ADDENDUM NO. 1

PROJECT NAME: Nebraska Union First Floor Selective Refurbishment
UNL PROJECT NUMBER: C026P336
BID INVITATION NUMBER: 2209-13-7200

CONSULTANT: Holland Basham Architects
ADDRESS: 119 S. 49th Ave, Omaha, NE

DATE OF ISSUANCE: 20 August 2013
DATE OF BID OPENING: 27 August 2013

MECHANICAL PLAN - SOUTH

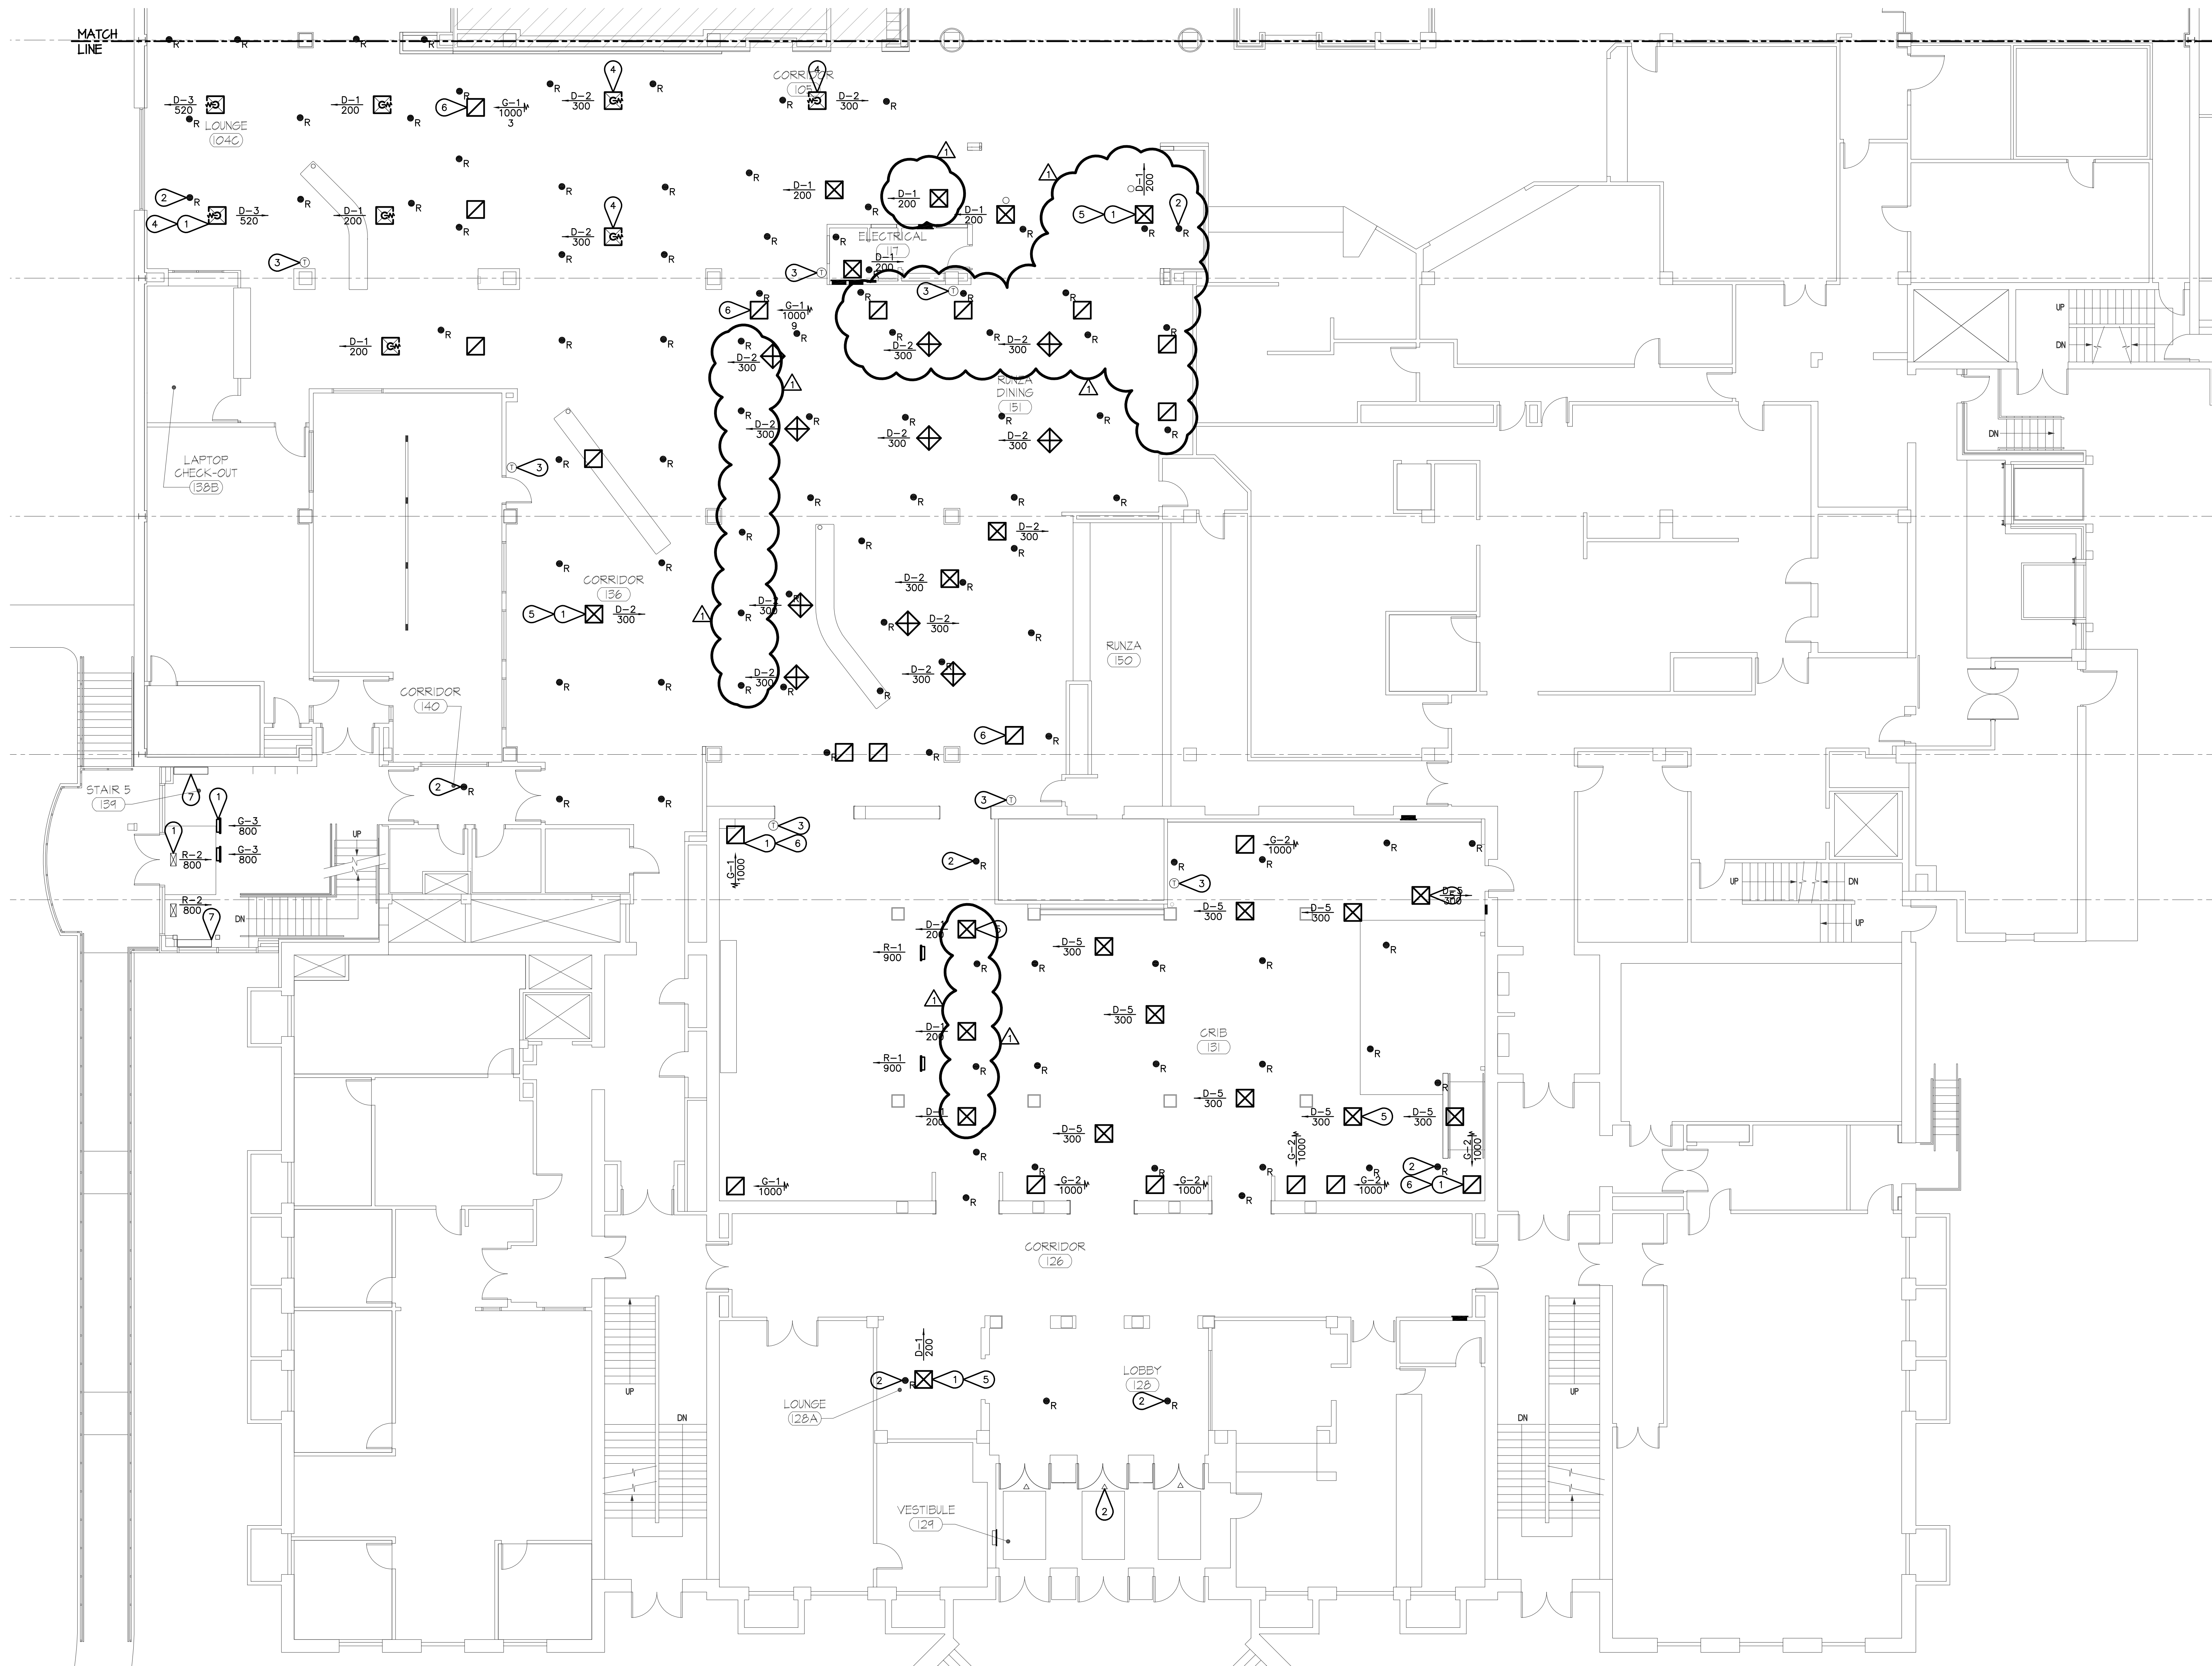
- a. Revised fire protection and diffusers in ceiling of dining area and crib.

**LIGHTING PLAN -
SOUTH - ALTERNATE BIDS**

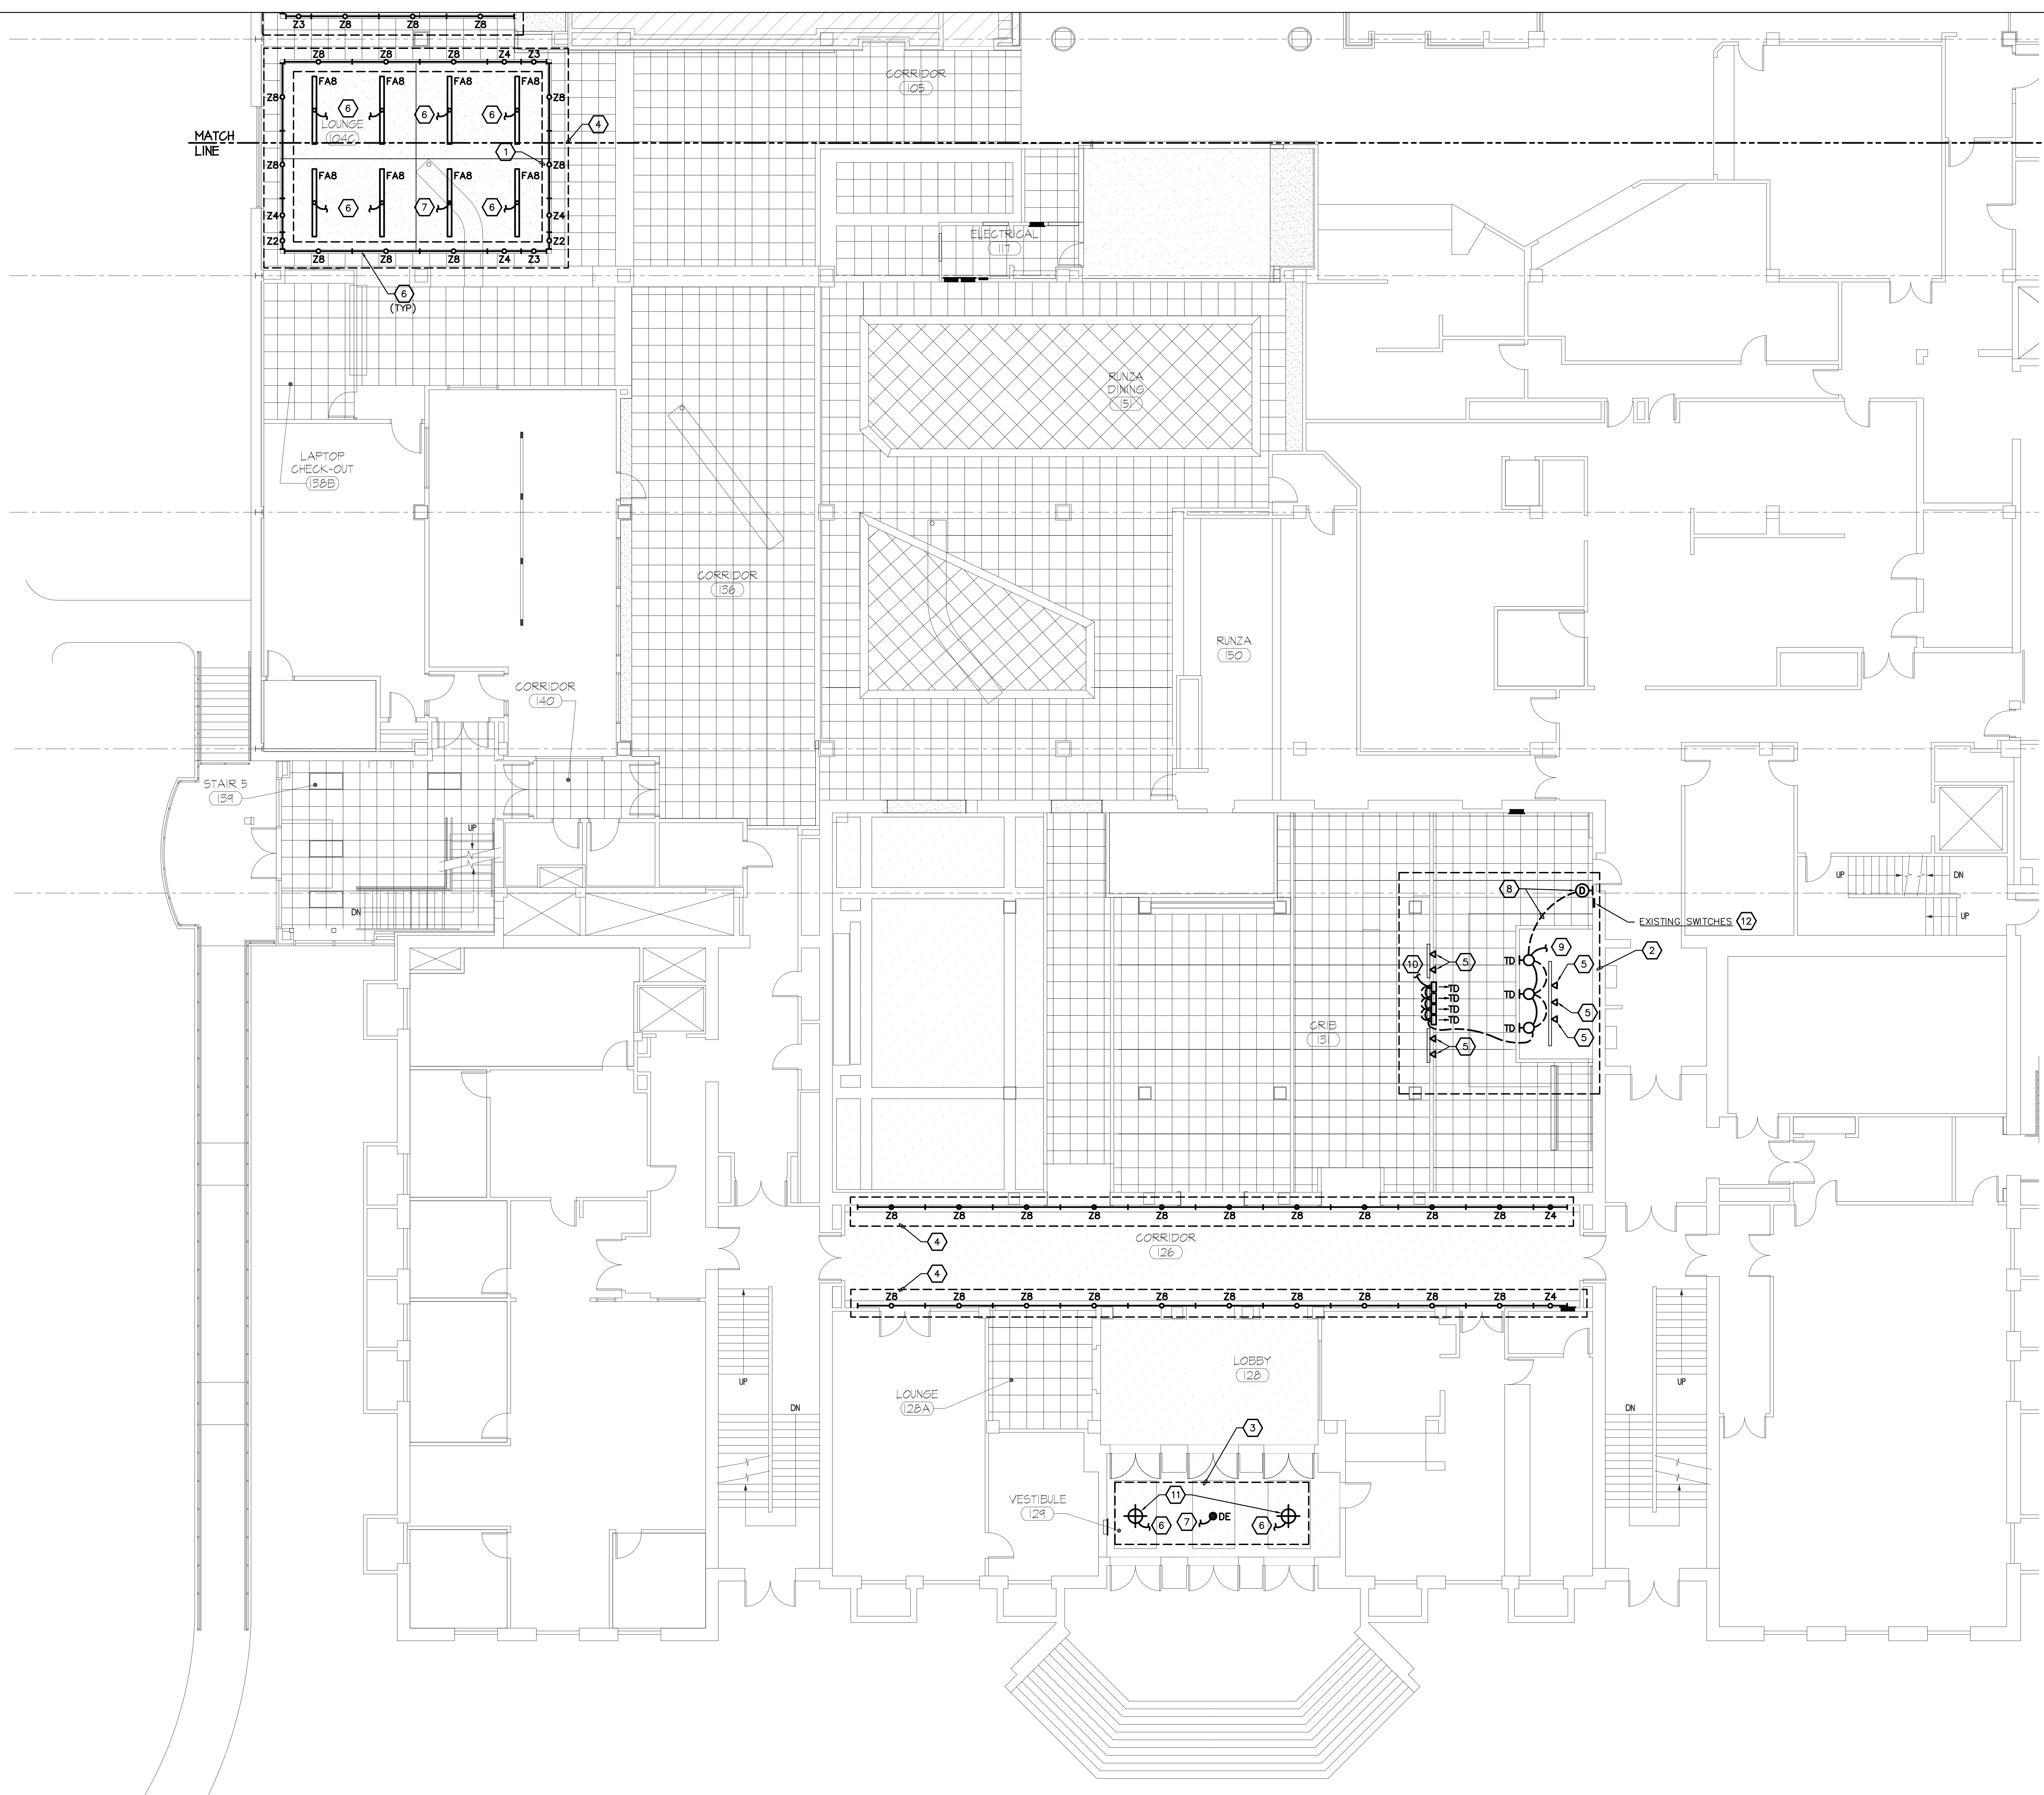
- a. Key note 11 updated to clarify relocation of existing pendants.

POWER & SPECIAL SYSTEMS PLAN - SOUTH
SCALE: 1/8" INCH = 1 FOOT
12" 0' 5' 10' 15'

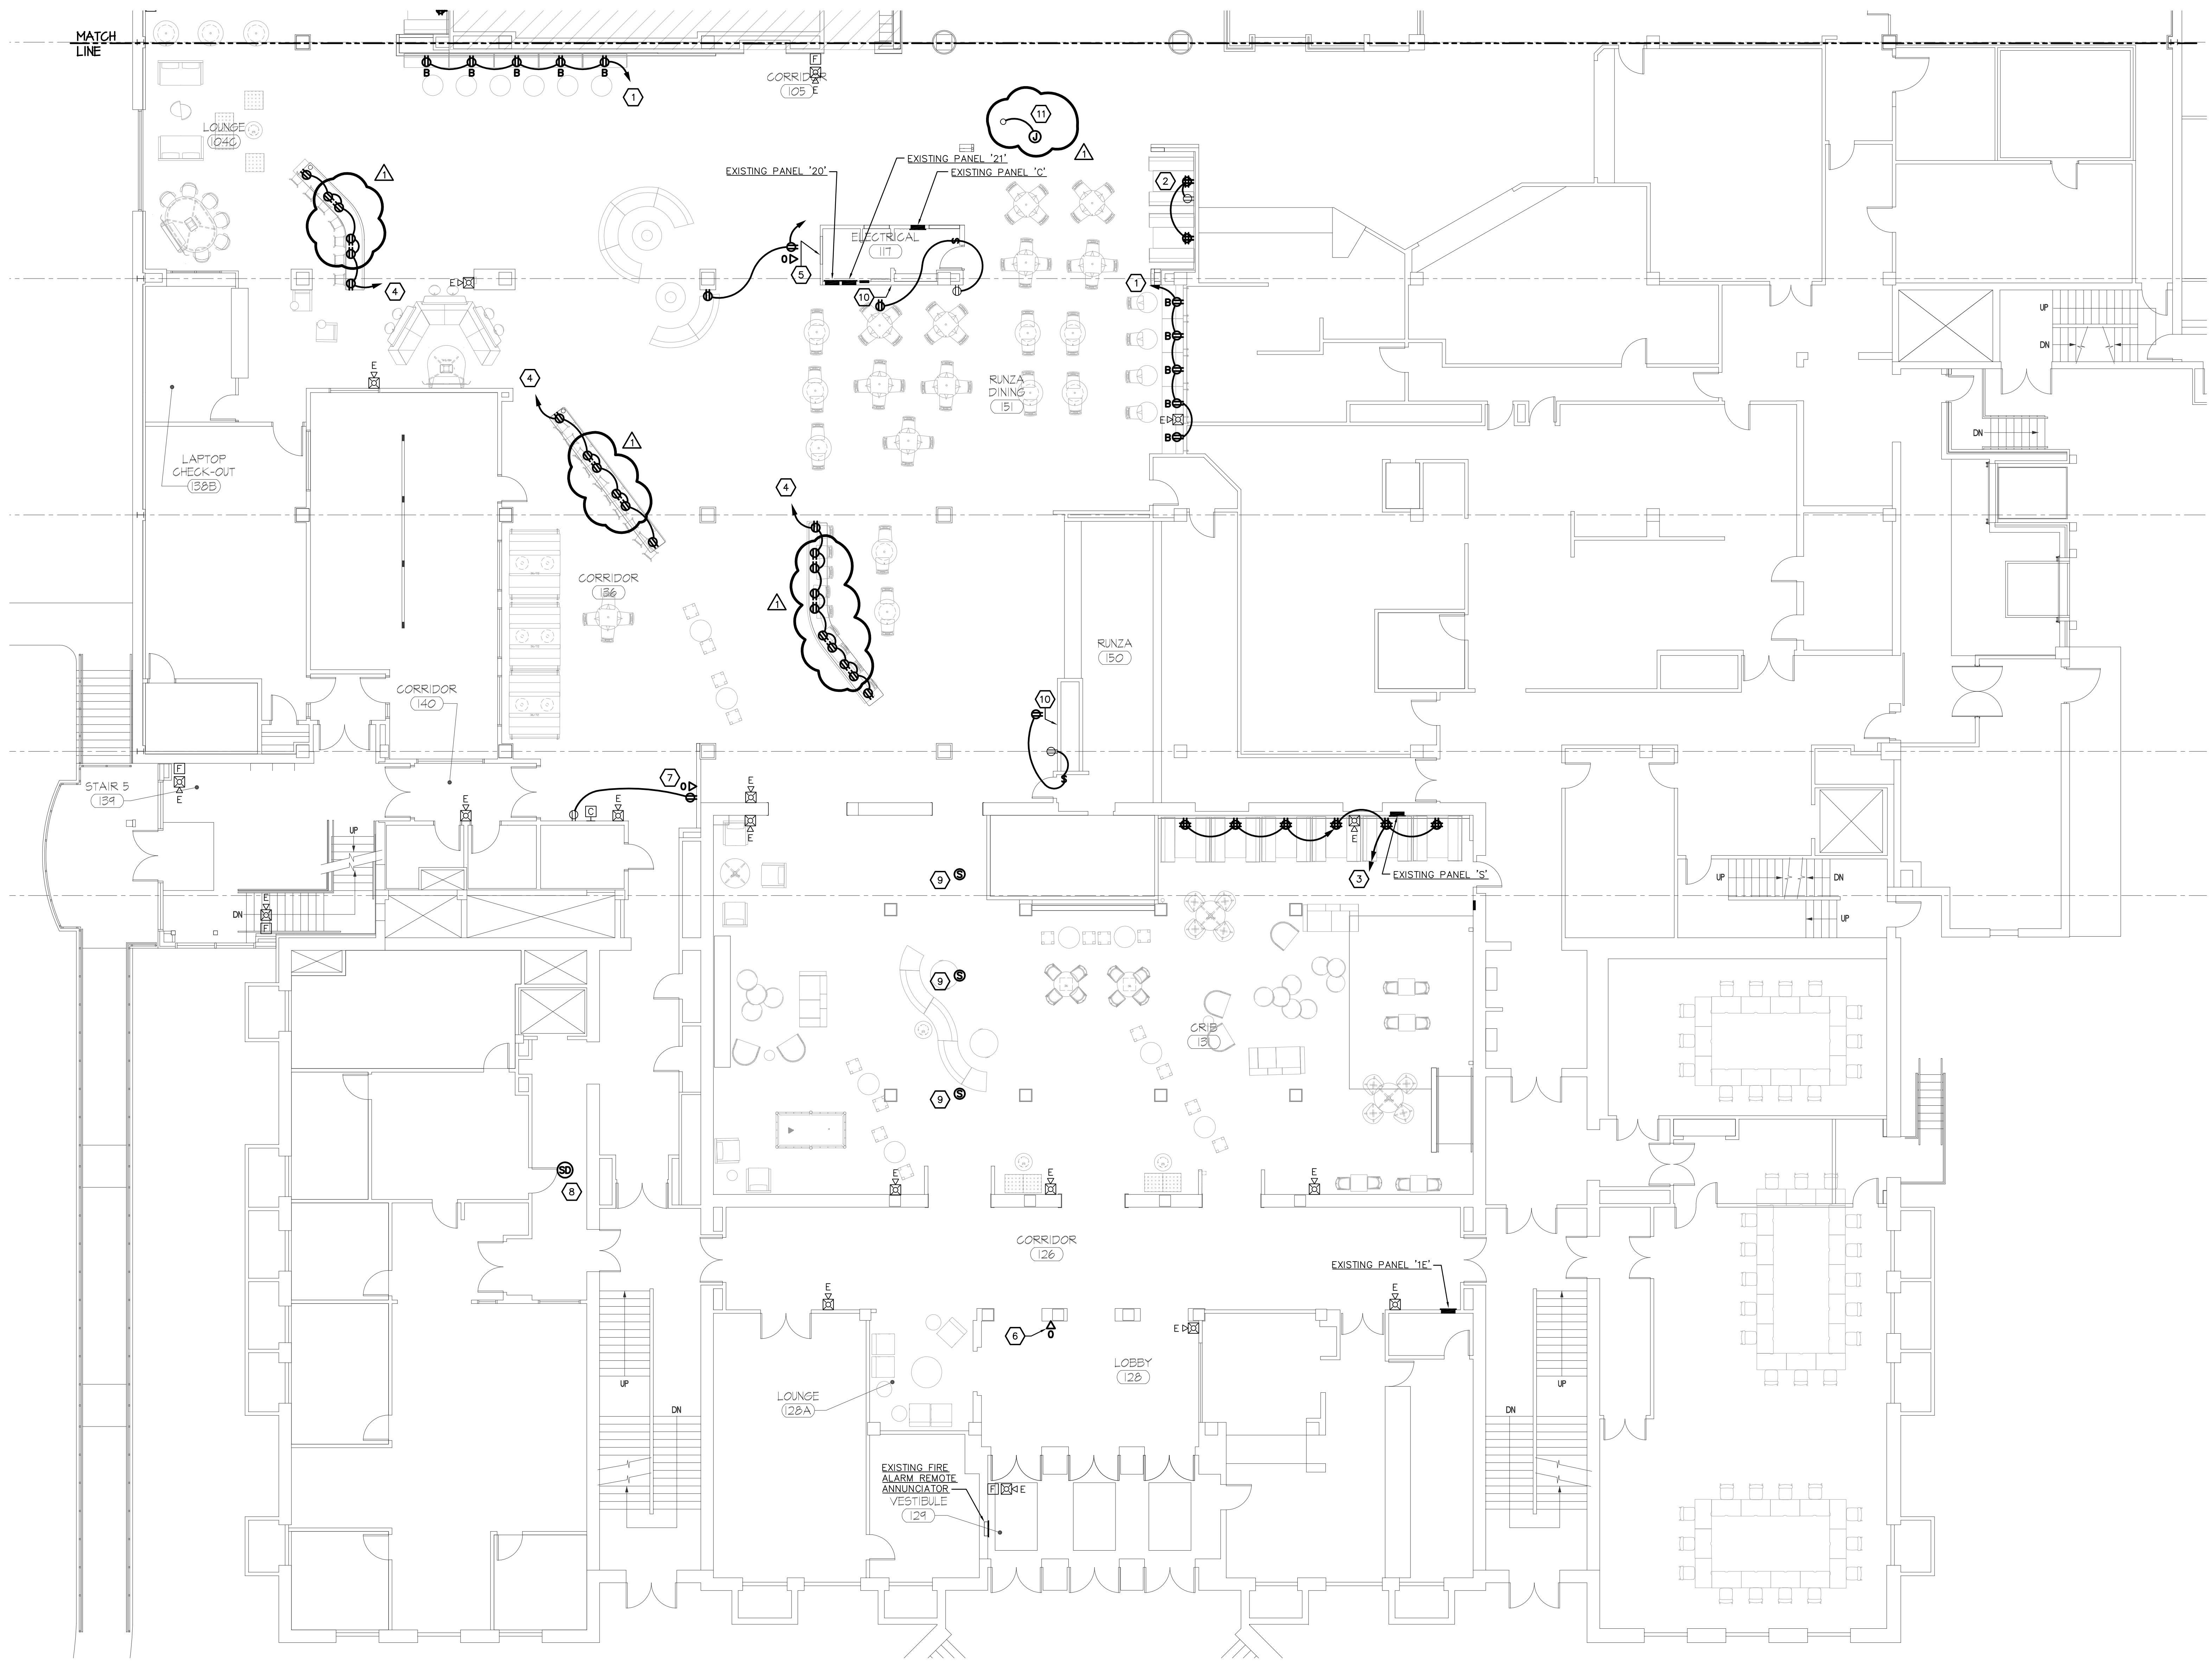
- a. Connect new Runza sign to existing lighting circuit.
- b. Delete two receptacles at north built-in table. Delete two receptacles at center built-in table. Add two receptacles at south built-in table.
